# ADDENDUM 2

**Gouverneur Central School District**  
**Reconstruction**  
**Senior High School**  
**SED Control No. 51-11-01-06-0-007-011**

**March 8, 2019**

**ADD-2**

AD-AR1

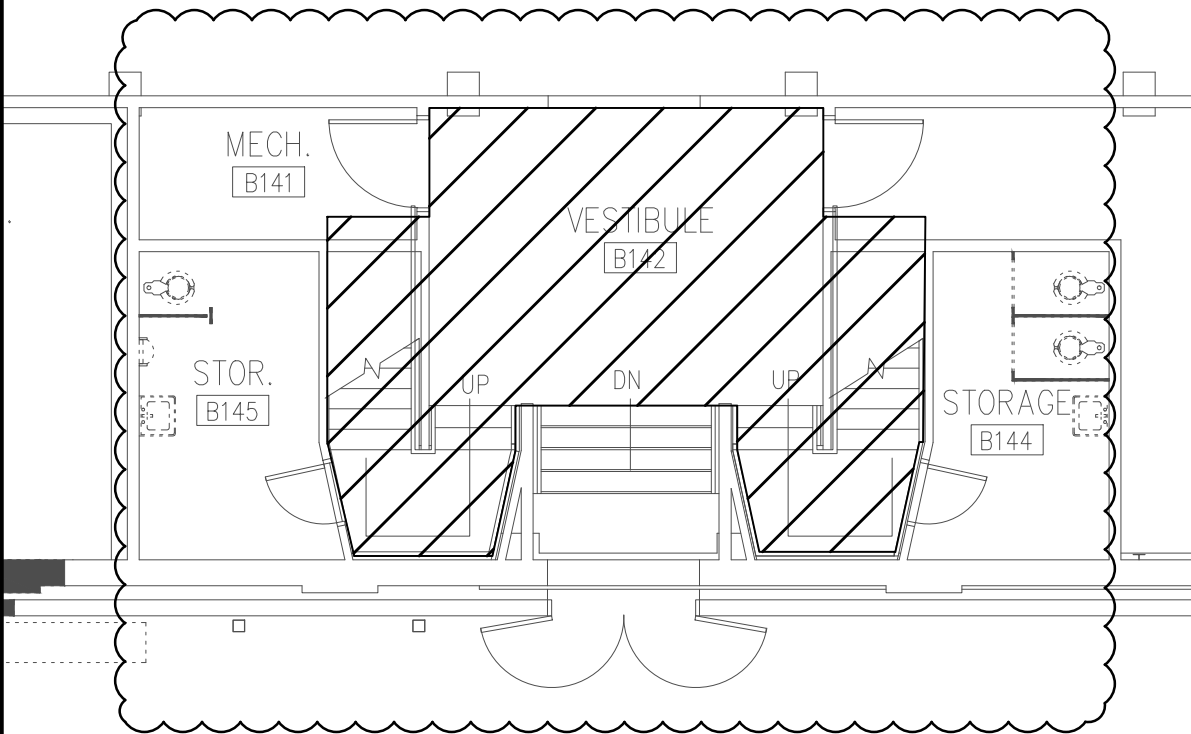
- ITEM 1. DRAWING AR103, FIRST FLOOR ASBETOS REMOVAL PLAN - AREA B
- A. **REVISE** this drawing as shown in attached Sketch AD-AR1.
- ITEM 2. DRAWING P102, FIRE FLOOR PLAN – EAST

VINYL ASBESTOS FLOOR TILE AND MASTIC REMOVAL  
IN THESE SPACES INCLUDED IN ALTERNATE 4.

1 PARTIAL BASEMENT REMOVALS PLAN - EAST  
 1/8" = 1'-0"

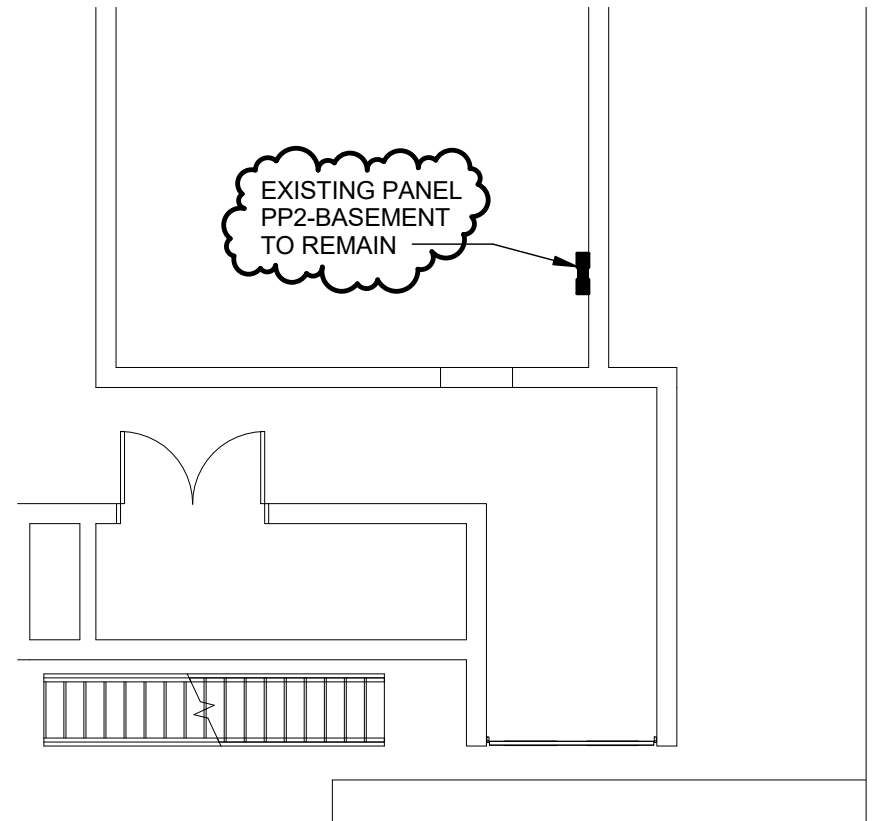
- ITEM 4. DRAWING ED101, PARTIAL BASEMENT REMOVALS PLAN
- A. Detail 2/ED101, "Partial Basement Removals Plan – East." **REVISE** label for existing Panel "PP-2" as indicated on attached Sketch AD-E1.

2 PARTIAL FIRST FLOOR REMOVALS PLAN - AREAS C & D  
 1/8" = 1'-0"

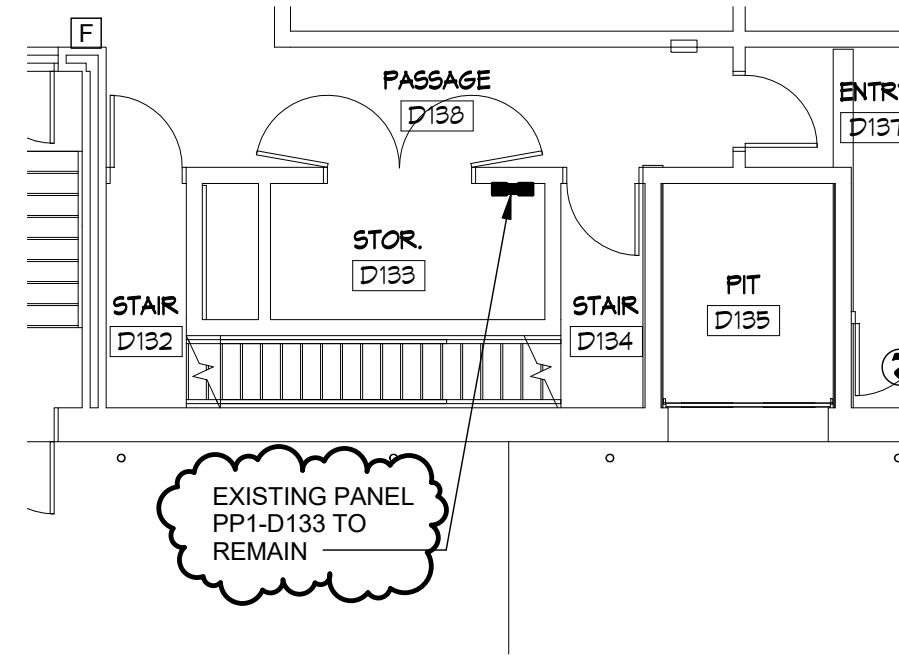
- ITEM 5. DRAWING ED103, PARTIAL FIRST FLOOR REMOVALS – AREAS C & D
- A. Storage D133. **REVISE** label for existing Panel "PP1" as indicated on attached Sketch AD-E1.

3 PARTIAL THIRD FLOOR REMOVALS PLAN - AREAS A & B  
 1/8" = 1'-0"

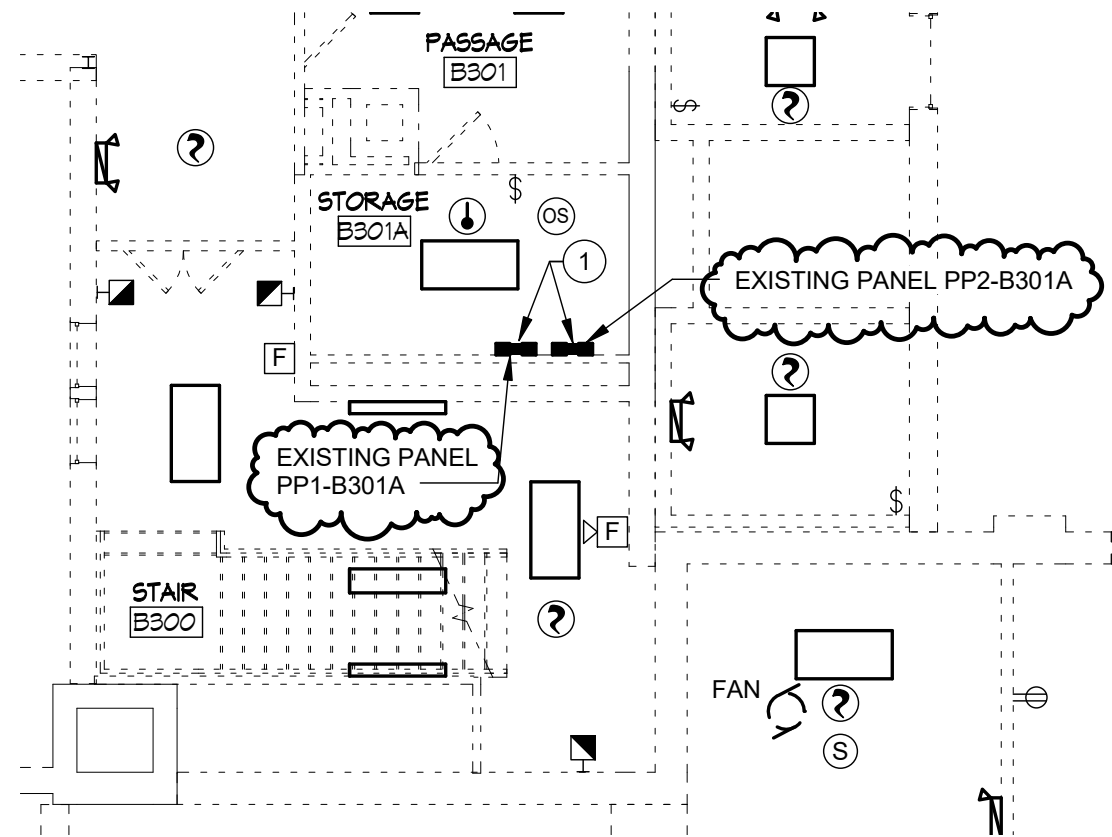
- ITEM 6. DRAWING ED106, PARTIAL THIRD FLOOR REMOVALS – AREAS A & B
- A. Storage B301A. **REVISE** the labeling of existing Panels "PP-1" and PP-2" as indicated on attached Sketch AD-E1.

DATE	03/07/19
BY	DHF/FJR
PROJ NO.	1537
SKETCH	ADDENDUM 2
	<b>AD-E2</b>
REF. DWG.:	E801

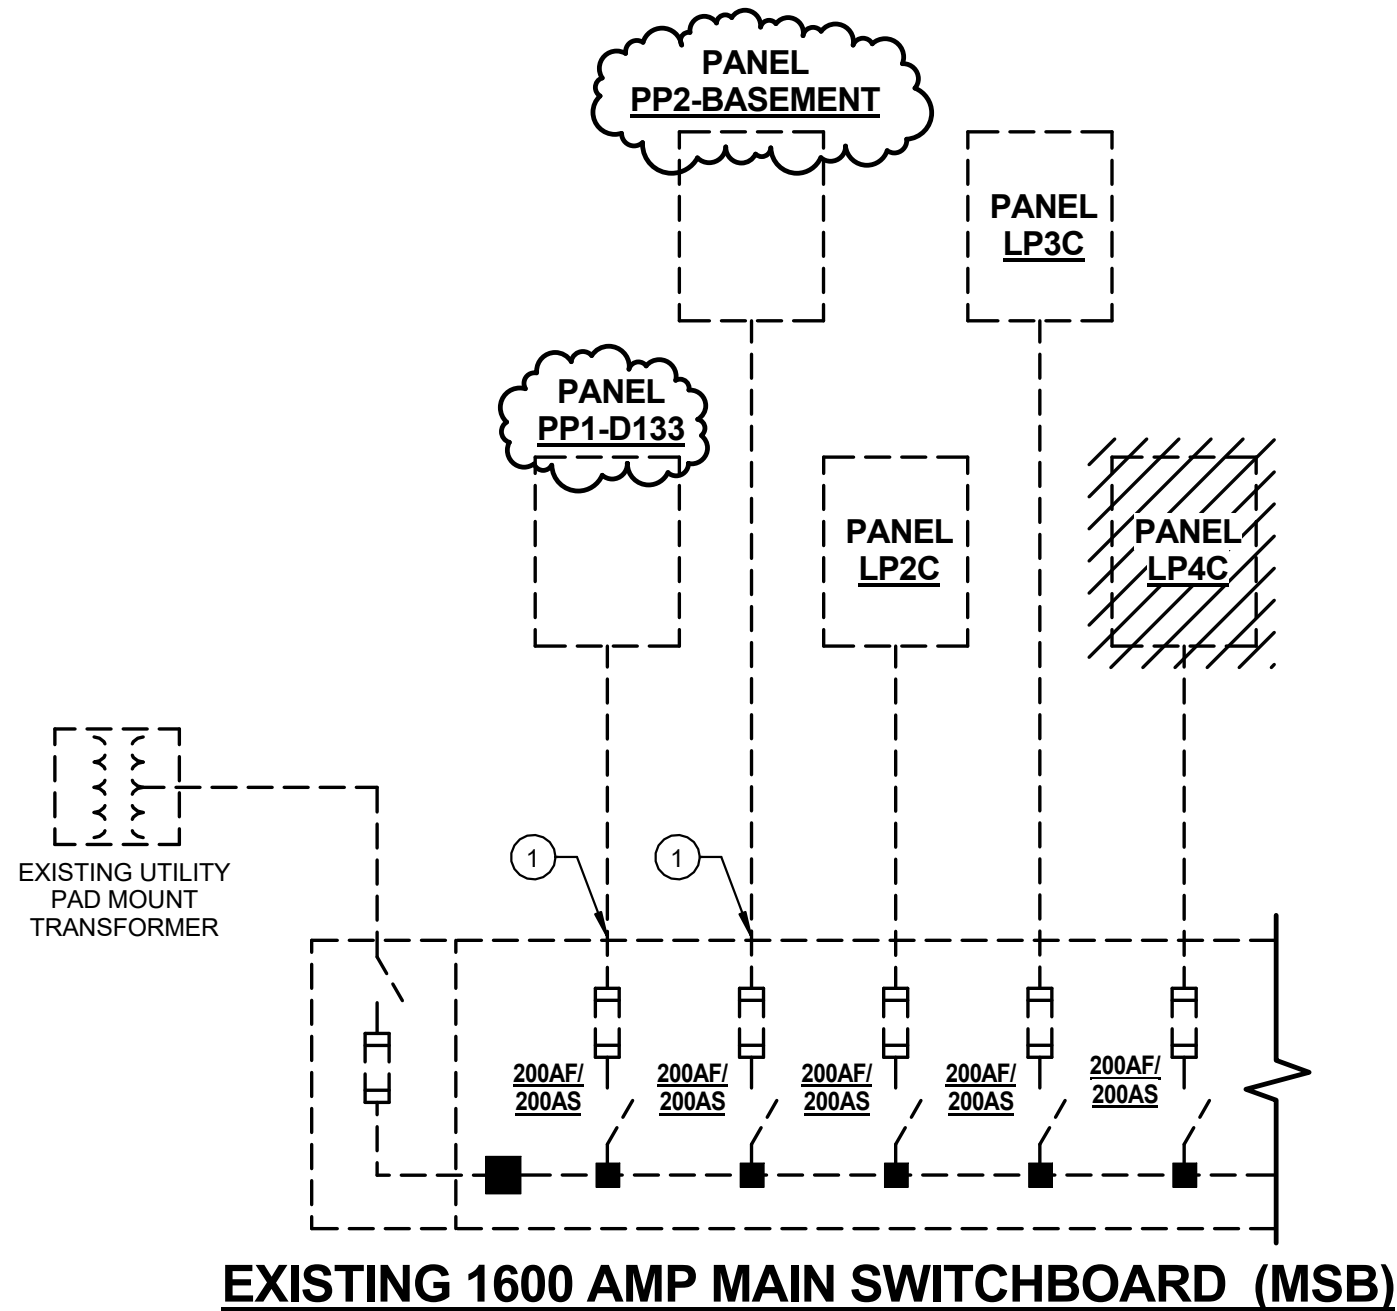
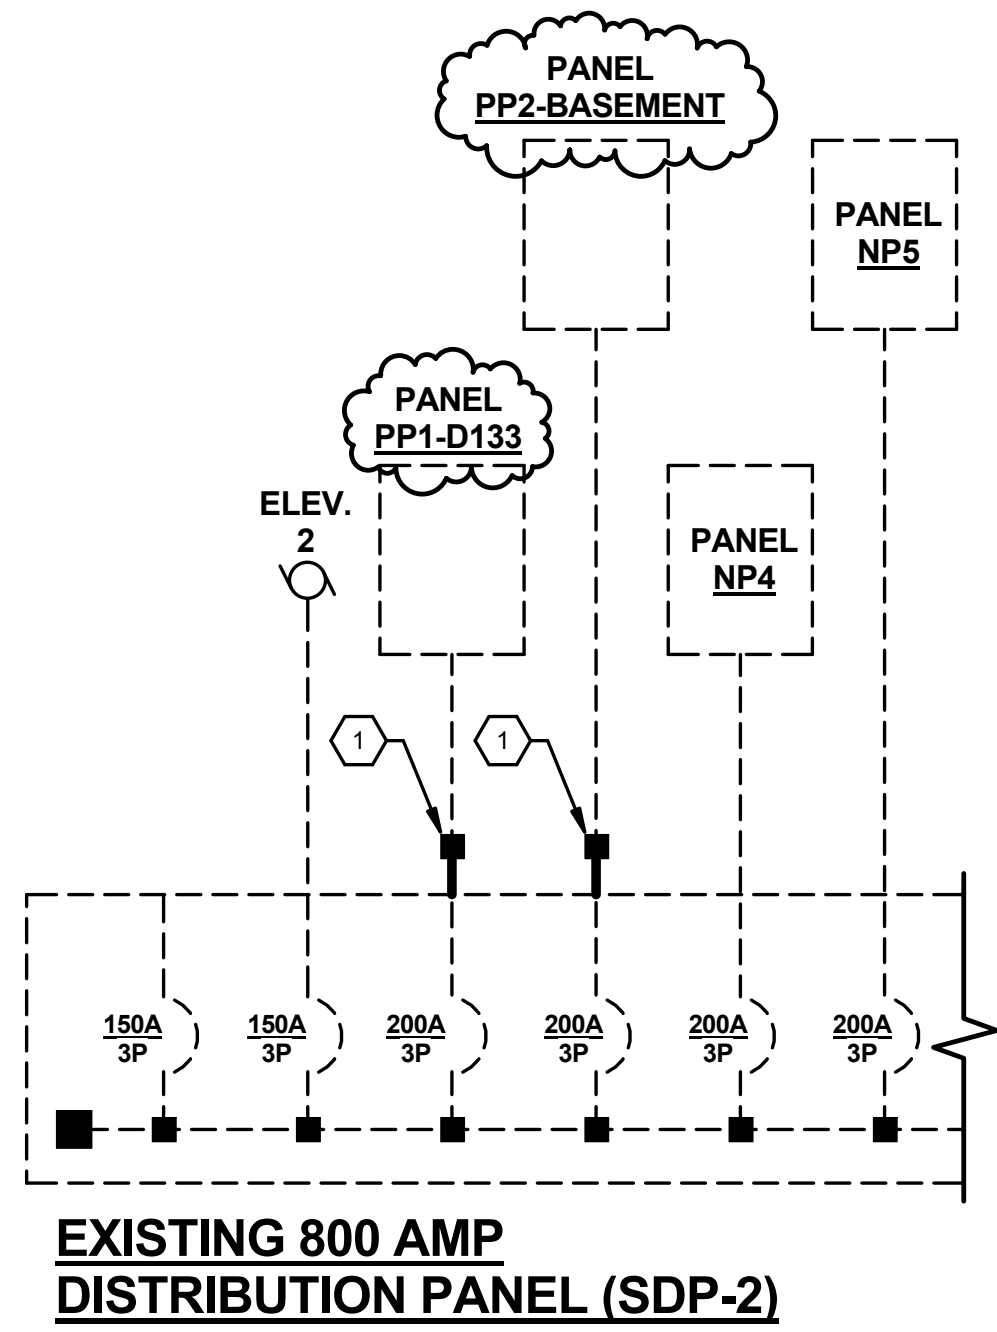
- A. Detail 3/E801 "Existing Power Distribution One-Line Diagram." **REVISE** the labeling for existing Panels "PP-1" and "PP-2" as indicated on attached Sketch AD-E2.

- B. Detail 4/E801, "Revised Power Distribution One-Line Diagram." **REVISE** labeling for Panels "PP-1" and "PP-2" as indicated on attached Sketch AD-E2.

AD-E3

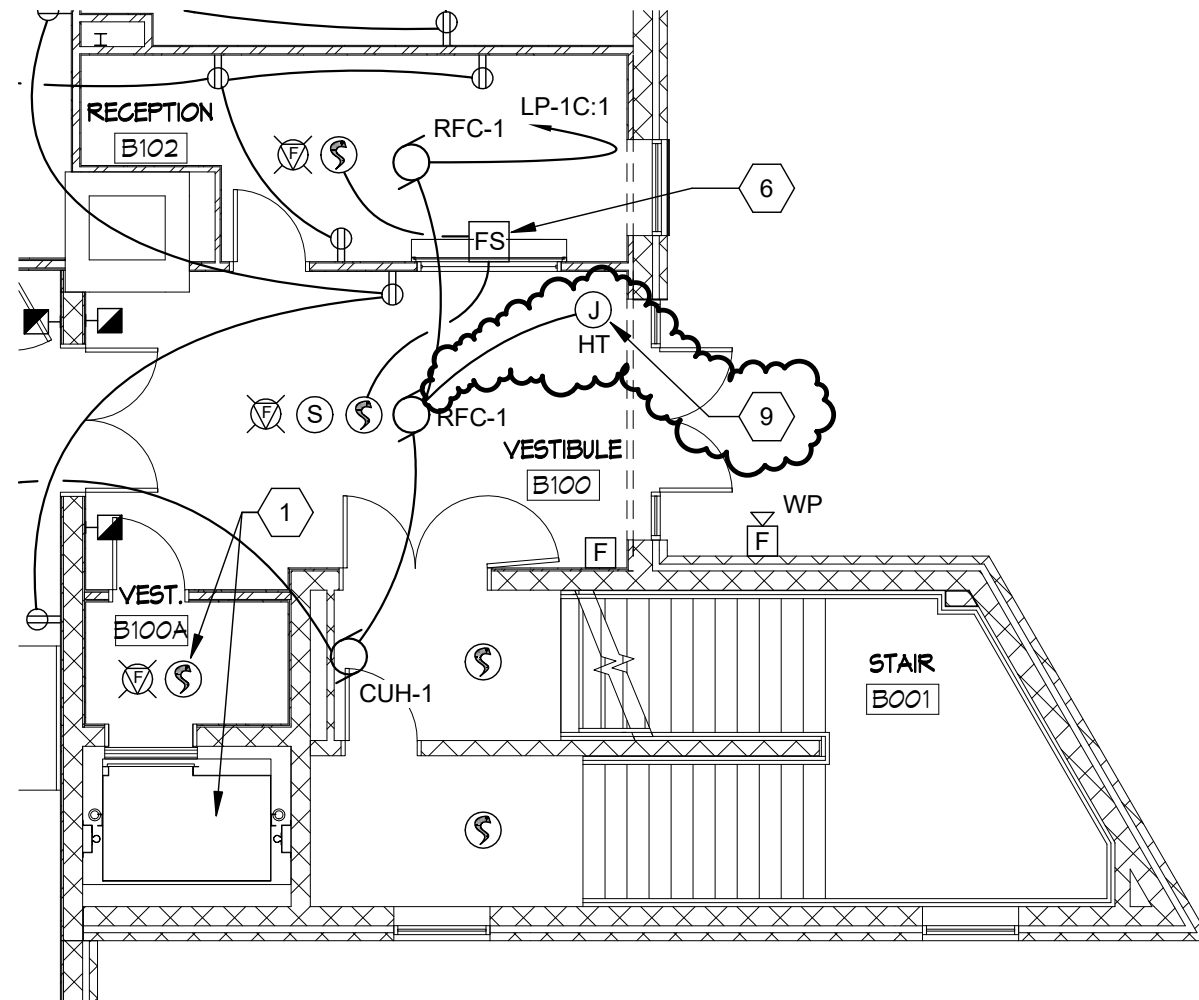
- ITEM 7. DRAWING E102, PARTIAL FIRST FLOOR – AREAS A/B POWER/SIGNAL
- A. Vestibule B100: **ADD** indication for junction box (HT) and Keyed Note 9 as indicated on attached Sketch AD-E3.

- B. Refer to "Keyed Notes This Drawing," **ADD** Keyed Note 9 as indicated on attached Sketch AD-E3.
- ITEM 8. DRAWING E801, POWER DISTRIBUTION ONE-LINE DIAGRAM

- 1 REFER TO ELEVATOR DETAIL ON DRAWING E001 FOR ADDITIONAL INFORMATION.
- 2 EXISTING PANEL LP-1C, PROVIDE FOUR 20A-1P CIRCUIT BREAKERS TO MATCH EXISTING CIRCUIT BREAKERS.
- 3 EXISTING PANEL LP-1E, PROVIDE FIVE 20A-1P CIRCUIT BREAKERS TO MATCH EXISTING CIRCUIT BREAKERS.
- 4 EXISTING PANEL NP4, PROVIDE NINE 20A-1P CIRCUIT BREAKERS TO MATCH EXISTING CIRCUIT BREAKERS.
- 5 MOUNT OUTLETS INDICATED AT THIS ROOM AT 48" AFF, UNLESS OTHERWISE INDICATED.
- 6 FIRE SHUTTER. PROVIDE FIRE ALARM CIRCUITING TO FIRE SHUTTER FROM FIRE ALARM PANEL VIA AUXILIARY CONTACTS AT ADJACENT SMOKE DETECTORS.
- 7 PROVIDE FIRE ALARM DEVICE AS PART OF ALTERNATE #4 ONLY.
- 8 FIRE ALARM DEVICES IN THIS ROOM ARE BASE BID.
- 9 JUNCTION BOX FOR CONNECTION TO HEAT TRACE, COORDINATE EXACT LOCATION WITH DIV. 22 CONTRACTOR PRIOR TO ROUGH-IN.

DATE	03/05/19
BY	AKM/FJR
PROJ NO.	1537
SKETCH	ADDENDUM 2
<b>AD-E1SS</b>	
REF. DWG.:	SS-E103

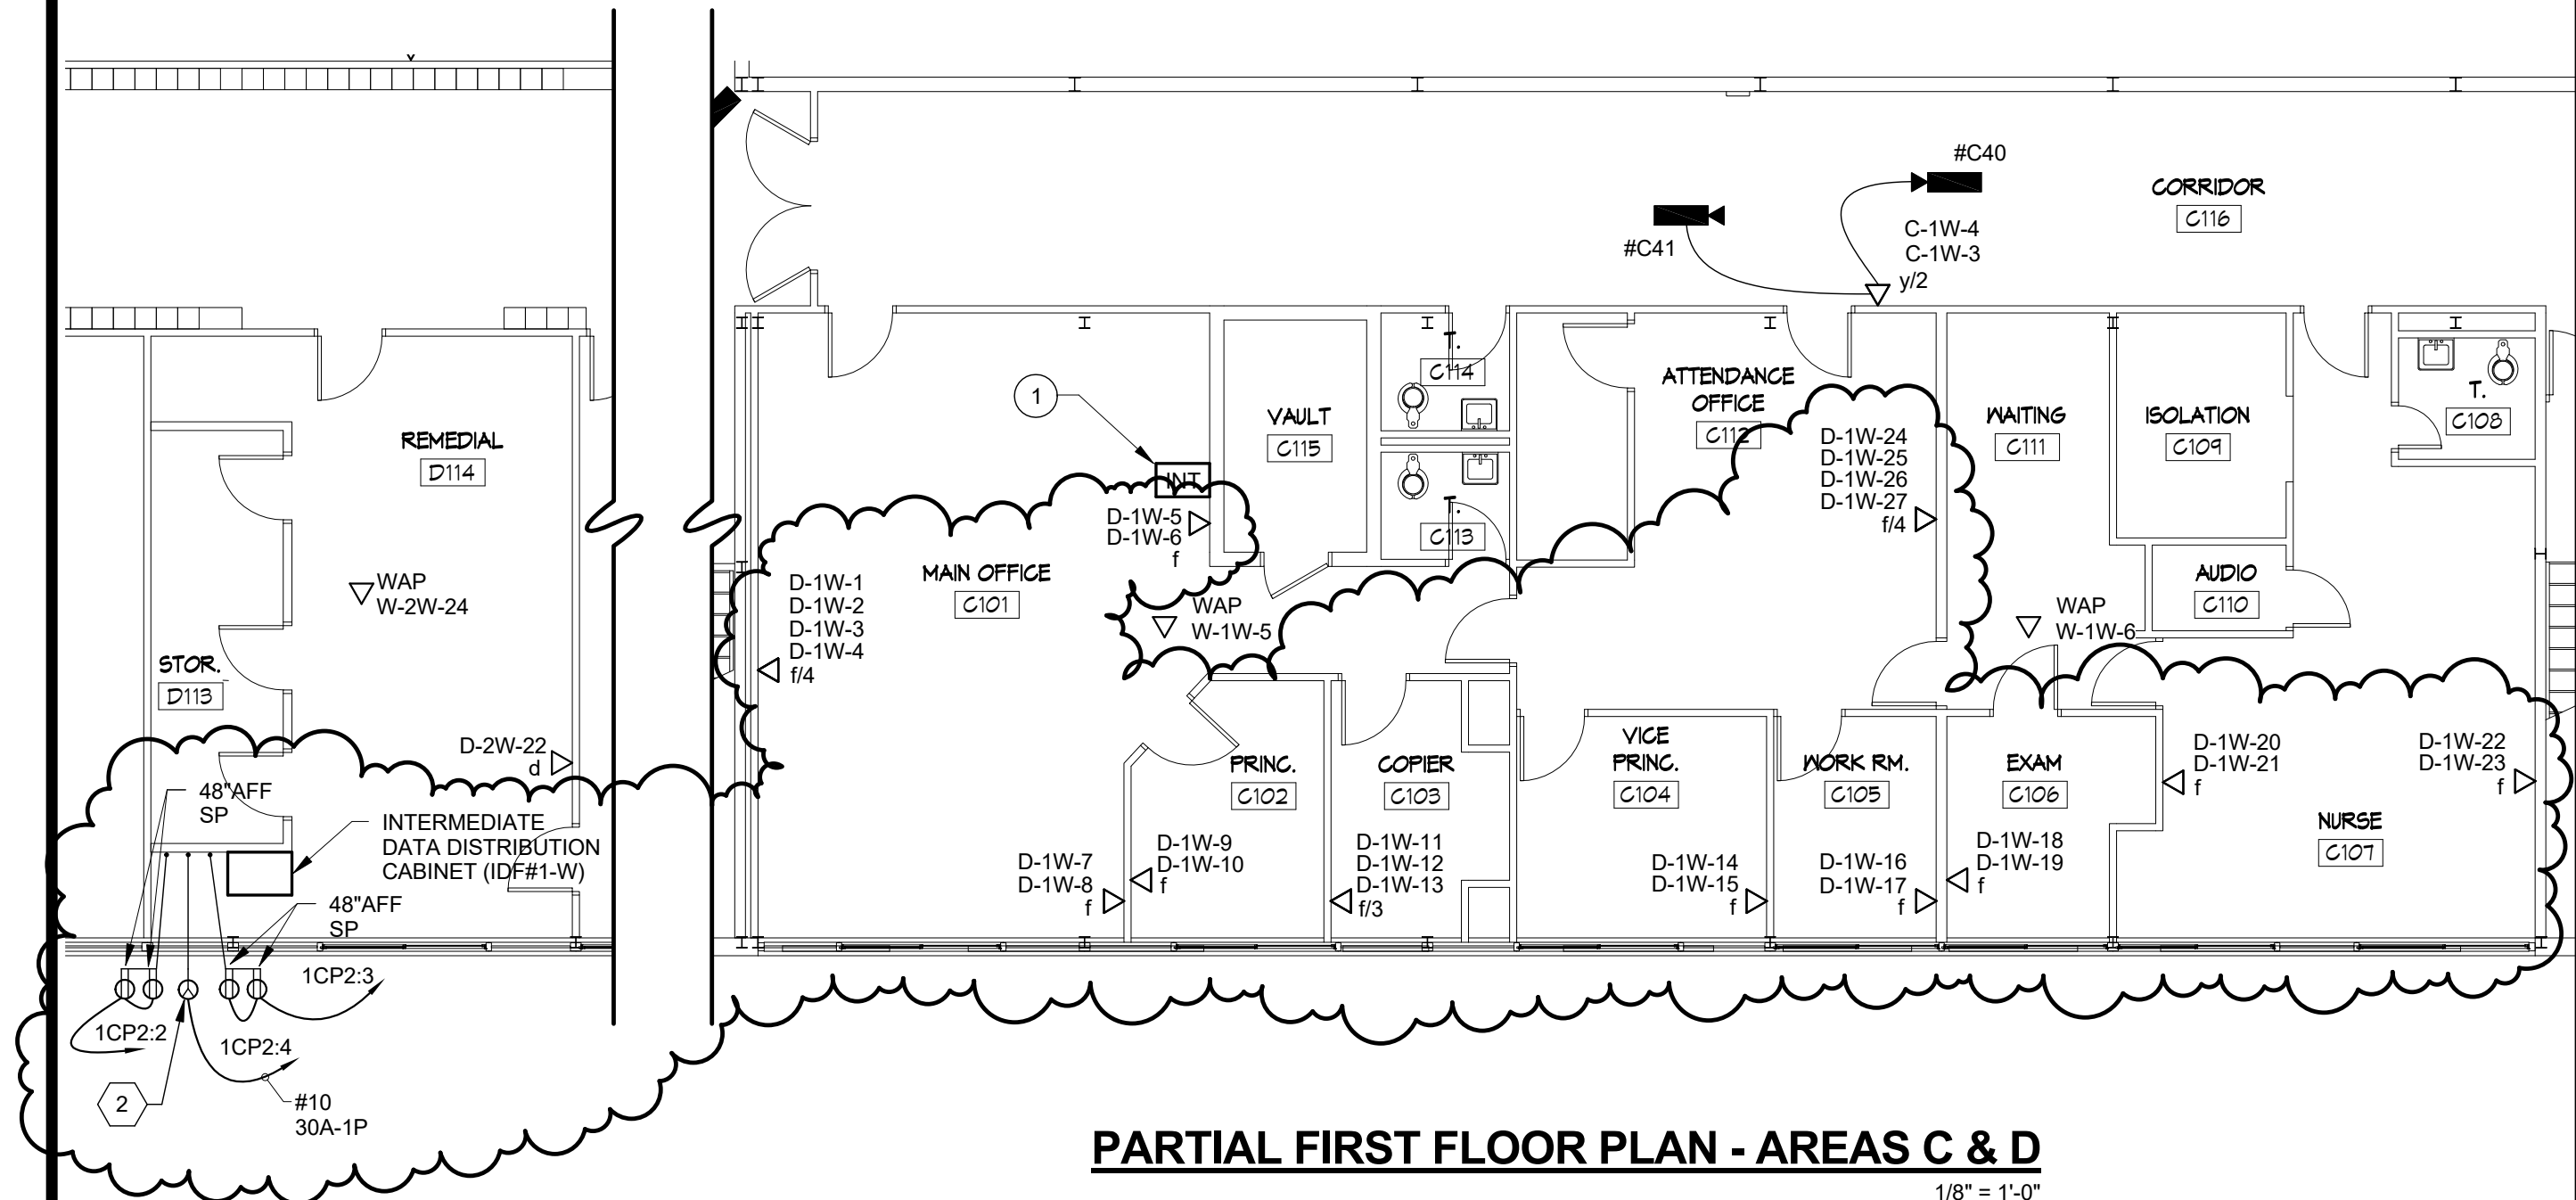
- A. Main Office C101, Principal C102, Copier C103, Vice Principal C104, Work Room C105, Exam C106, Nurse C107, Attendance Office C112, and Remedial #D114, **PROVIDE** data adds and revisions as indicated on attached Sketch AD-E1SS.
